Sundry Print Report

| Well Name: GULF FEDERAL | Well Location: T26S / R29E / SEC 23 / SWSW / | County or Parish/State: EDDY / NM |

Type of Action: Plug and Abandonment

Stephens & Johnson Operating Co.
Gulf Federal Well No. 1
API No. 3001524799
Eddy county, New Mexico

— Proposed Plug and Abandonment —

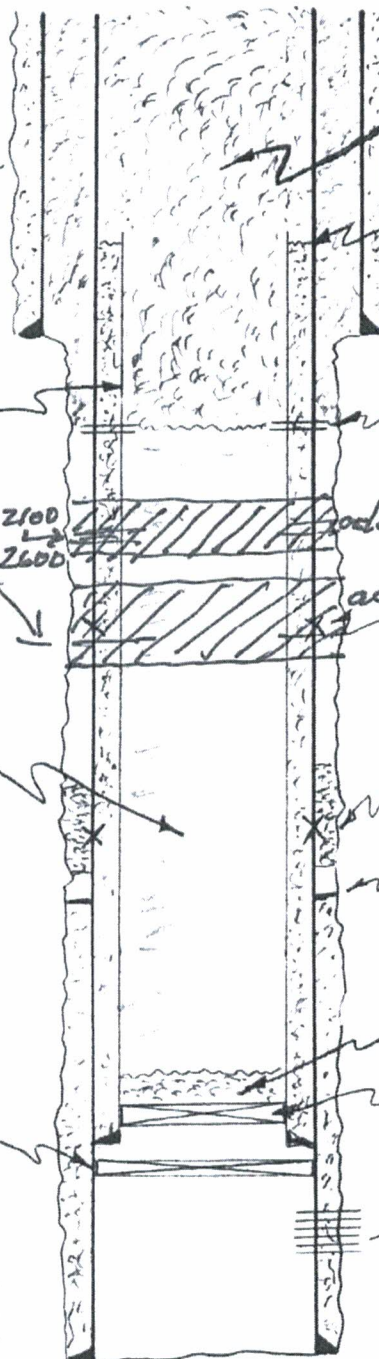
Approval subject to the following changes, COA's:

→ Add: Perf 4" and 5 1/2" Casing @ 2970', Sgz
cmt to 2600' (Covers Top Delaware and Base
of Salt). WOC Tag No lower than 2600'.

Perf 4" and 5 1/2" Casing @ 2230', Sgz
cmt to 2100' (Covers Top of Salt) WOC Tag
No lower than 2100'.

add CSG leak 2894'-2927'

1. TIH with tubing to CIBP at 4793', and circulate hole with 9.5lb/gal salt gel mud. TOOH with tubing.
2. Spot 25 sx cement on top of CIBP @ 4793'.
3. Perforate 4" liner and 5-1/2" casing at 2970', sqz cement to 2600' (covers Top Delaware and Base Salt). WOC and tag no lower than 2600'.
4. Perforate 4" liner and 5-1/2" casing at 2230', sqz cement to 2100' (covers Top Salt). WOC and tag no lower than 2100'.
5. Perforate 3 sqz holes through 4" liner and 5-1/2" casing @ 550'.
6. Cut off 4" liner at 390'. TOOH with 390' of 4" liner.
7. Circulate 150 sx cement down 5-1/2" casing and 4" liner and out sqz holes at 550' and back up to surface between 5-1/2" casing and 8-5/8" surface casing.
8. Cut off wellhead and install 4' standard P&A marker.
